Product Change Notification (PCN)

PCN Number: PCN_IndHCM_20261110 Affected Series: WE-HCM Affected Part Number: see table "PART NUMBER, REVISION & DATASHEET" PCN Date: 2026-08-10 (YYYY-MM-DD) Effective Date: 2026-11-10 (YYYY-MM-DD)	Change Category: ☐ Equipment/Location ☒ General Data ☐ Material ☐ Process ☐ Product Design ☐ Shipping/Packaging ☐ Supplier ☐ Software
Contact: Product Management Phone: +49 (0) 7942 - 945 5001 Fax: +49 (0) 7942 - 945 5179 E-Mail: pcn.eisos@we-online.com	Datasheet Change: ☒ Yes ☐ No Attachment: ☐ Yes ☒ No

Due to datasheets standardizations, Würth Elektronik eiSos is updating the internal measurements to ensure alignment with the company's current specifications.

SIZE 1052 / PART NUMBER 744306020, 744306025, 744306030:

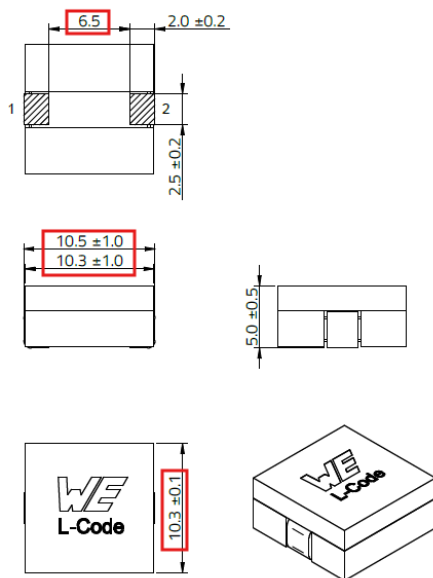
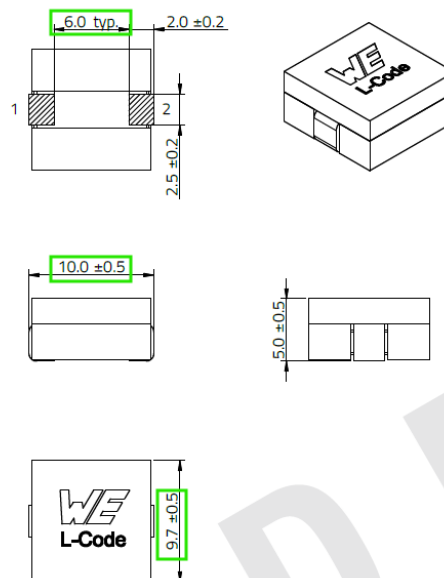
To avoid discrepancies between the mechanical drawings and production specifications, Würth Elektronik eiSos has adjusted all mechanical dimensions where the drawings did not reflect the actual component dimensions for all part numbers listed in the table "PART NUMBER, REVISION & DATASHEET".

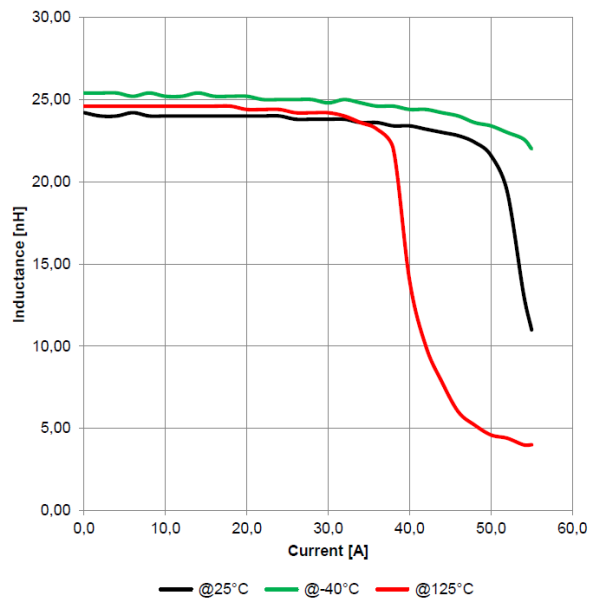
To improve the clarity of the datasheet layout, Würth Elektronik eiSos has restructured the complete datasheet for part number 74431821100 by removing the Parallel, Three-turn, and Two-turn configurations and showing only the One-turn topology:

Typical Inductance vs. Current Characteristics:

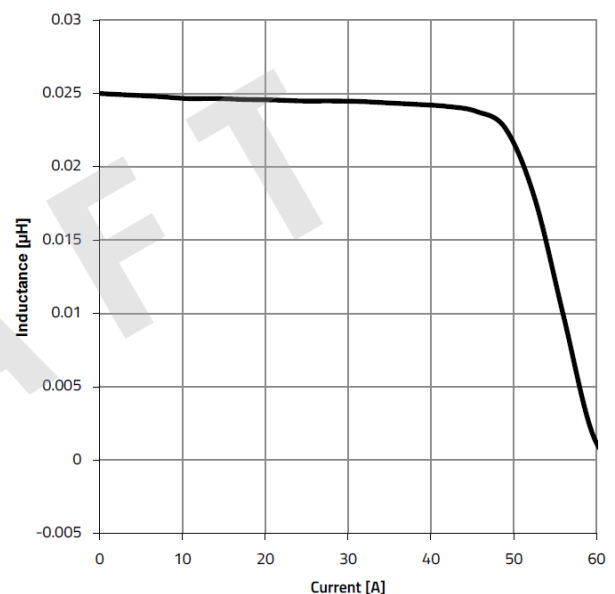
As [REDEXPERT](#) already provides Typical Inductance vs. Current Characteristics information at different temperatures, Würth Elektronik eiSos has remeasured and improved the Typical Inductance vs. Current Characteristics graphs and revised the datasheet to show only Typical Inductance vs. Current Characteristics at 20°C for the affected part numbers:
